Item 4.**Development Application: 331-337 Kent St, Sydney - D/2021/35**

File No.: D/2021/35

Summary**Date of Submission:** 2 February 2021

Proposal Summary: Approval is sought for alterations and additions to the existing 10-storey commercial building at 331-337 Kent Street, including significant demolition of existing building elements, structural upgrade works, and refurbishment of the existing four-storey historic warehouse facade. A new four storey addition is proposed resulting in a 15 storey commercial/retail building with a total building height of 61.73m (RL 80.125). Works to the existing ground level carpark are proposed, including new end of trip facilities, bicycle parking, loading and servicing bays, courier parking spaces, and building plant and services. Minor excavation to facilitate a new lift pit is proposed.

Figure 64: Overshadowing diagrams 21 June - 9.00am - 110-116 Sussex Street

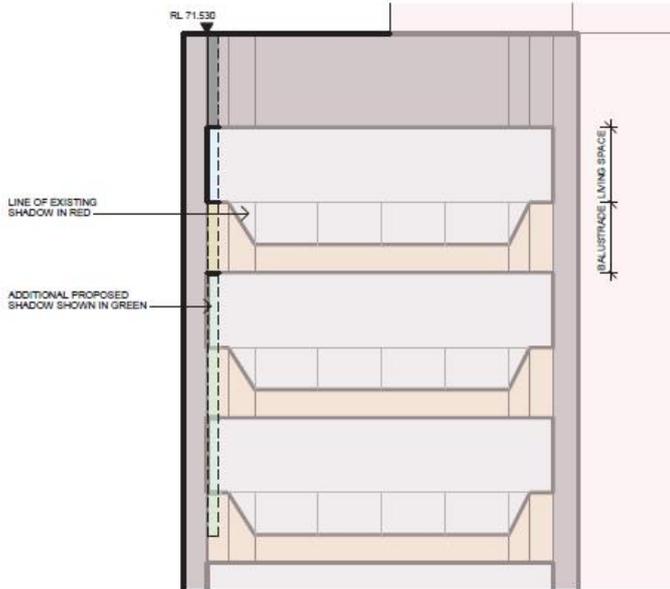
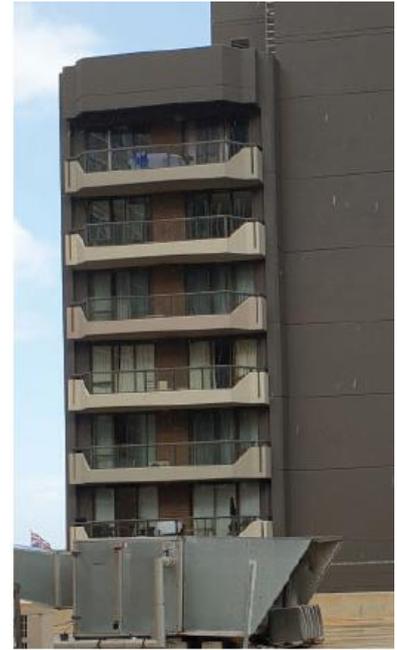
113. The applicant was asked to clarify the overshadowing impacts to this property, and more detailed overshadowing diagrams were submitted, showing the solar access impacts in green below, between 9am and 9.15am, to the balustrade of the balcony of the top unit.
114. The diagrams show that the subject proposal may affect the solar access to the private balconies and bedroom windows of the two top southern apartments between 9am and 9.15am on June 21. These openings are largely in shadow for the rest of the day between 10am and 3pm on June 21 and the proposal reduces the sunlight received so that the resultant solar access between 9am and 9.15am is nil.

115. However, given the proposal's consistency with the relevant height, FSR and setback controls, and the context of the site in a dense urban environment, it is considered that the overshadowing impact caused by the subject building is reasonable and thus supported. The measurable impact of 15-30 minutes loss of sunlight to a bedroom window and bedroom balcony between 9am and 9.30am is minor in the context of the site and the proposal's compliance with the FSR and height controls. Further, given the dual-facing layout of the apartments it is likely they would rely on most of their solar access from the western facade.

Figure 71: Sun eye diagrams 21 June 12pm-3pm

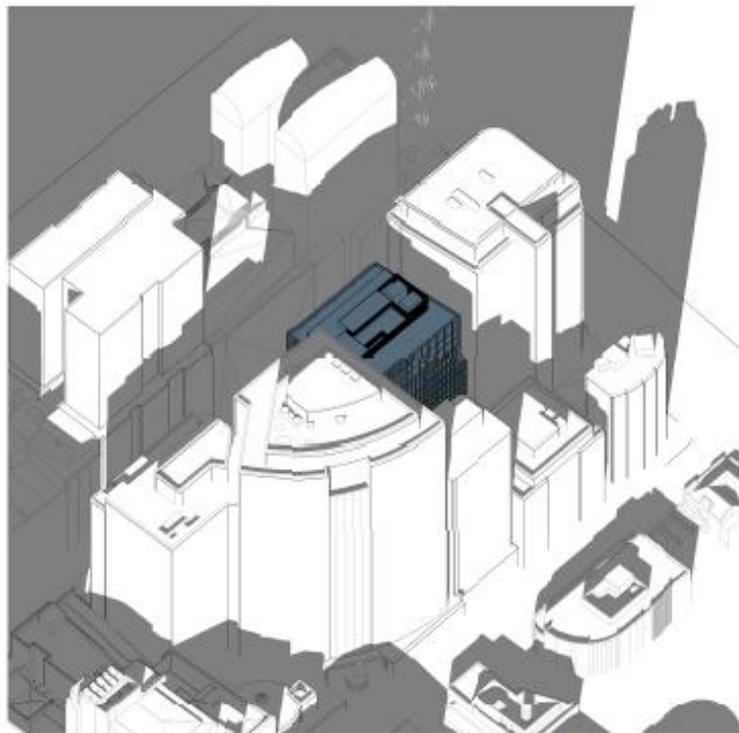
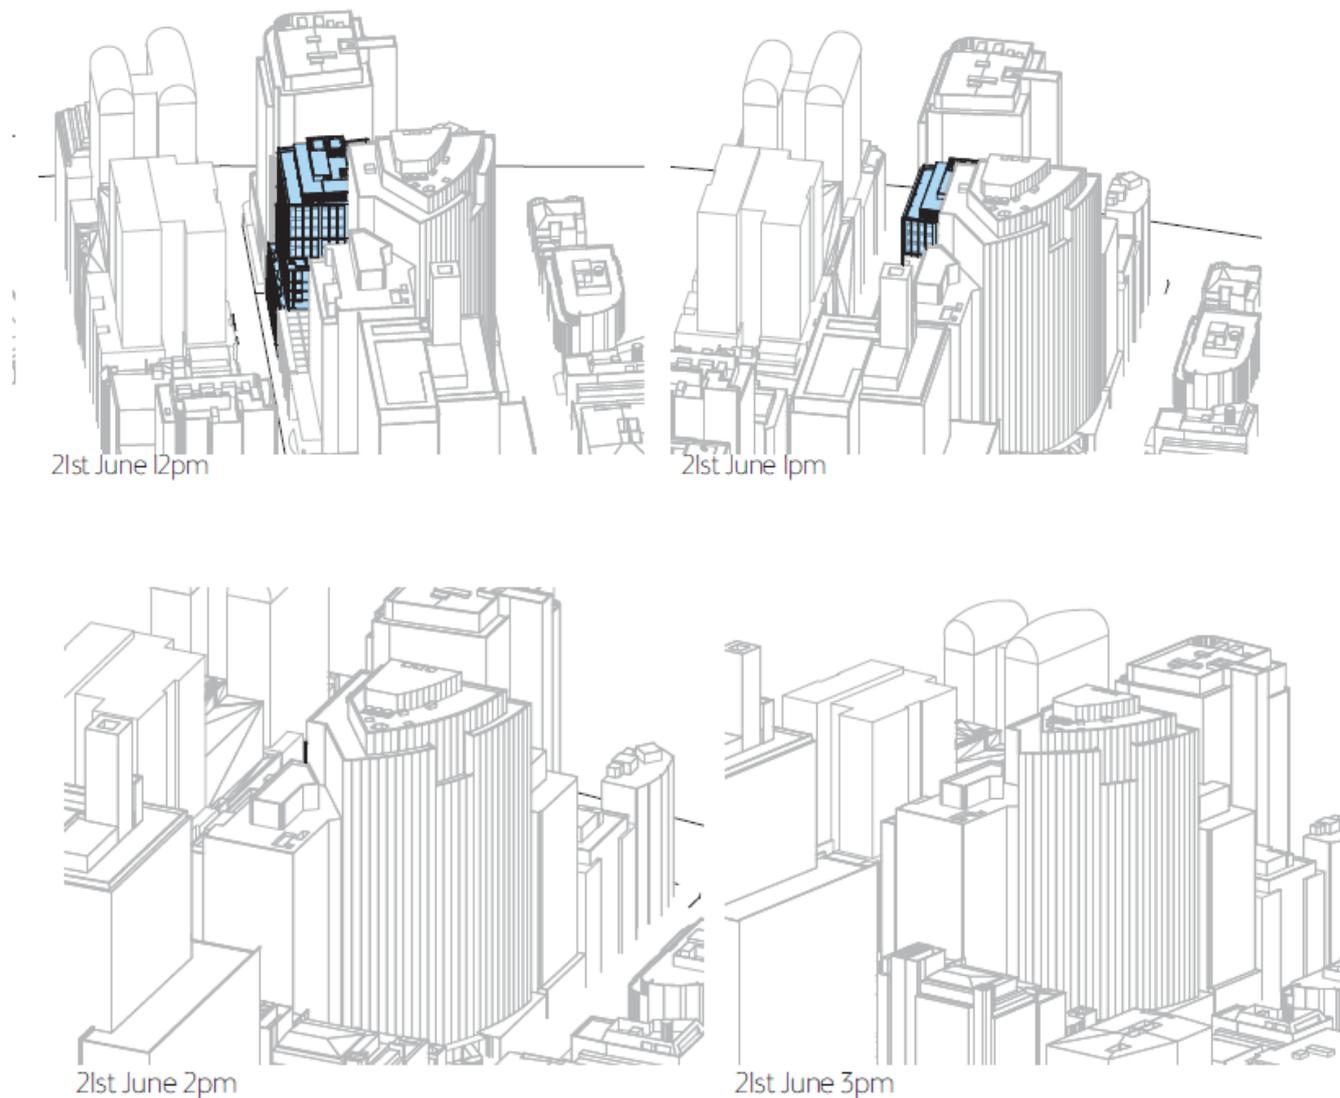
117. The sun's eye diagrams provided by the subject applicant demonstrate that the proposal does not cause additional overshadowing to 161 Clarence St between 12pm and 3pm on June 21, as the building is overshadowed by the existing tower at 309-329 Kent St.
118. Regardless, the conclusions drawn under D/2013/1851 were that the minor overshadowing to 161 Clarence Street was acceptable. In addition, the height approved under the concept DA D/2013/1851 was almost 20m higher than the subject DA. In this regard, the overshadowing impact from this proposal is likely to be less than that resultant under D/2013/1851.

119. On balance, there are no significant overshadowing impacts to neighbouring residential properties or the public domain. The proposal is consistent with Section 4.2.3 of the Sydney DCP 2012, and Clauses 6.19 and 6.21 of the Sydney LEP 2012.

Figure 72: Amended landscape section - Level 9 terrace

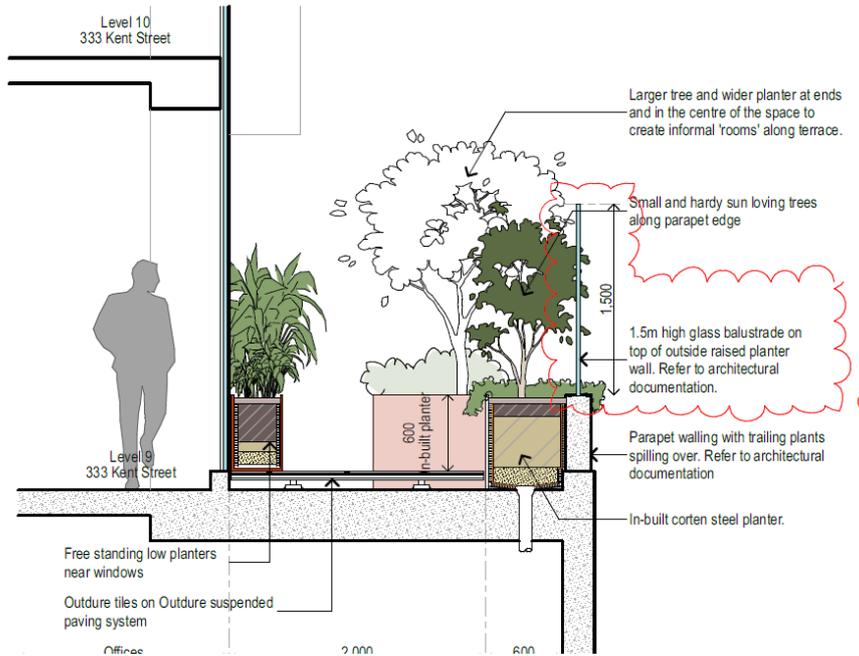
- (e) **Issue:** Request to delete the northern terrace on Level 9 due to privacy and amenity impacts to 309-329 Kent Street commercial building.

Response: The terrace is proposed for use by office workers and is not a public space. Conditions to mitigate amenity impacts from use of the terraces are recommended in Attachment A including hours of use and no use of speakers or music outside. Suitable height planting/screening to minimise wind impacts is included to the northern boundary, which is considered to prevent overlooking to the commercial tenancies at the neighbouring site. Further, the terrace is situated some 20m above the existing canopy of the neighbouring site, which is considered to be an adequate distance so as to minimise overlooking opportunities.
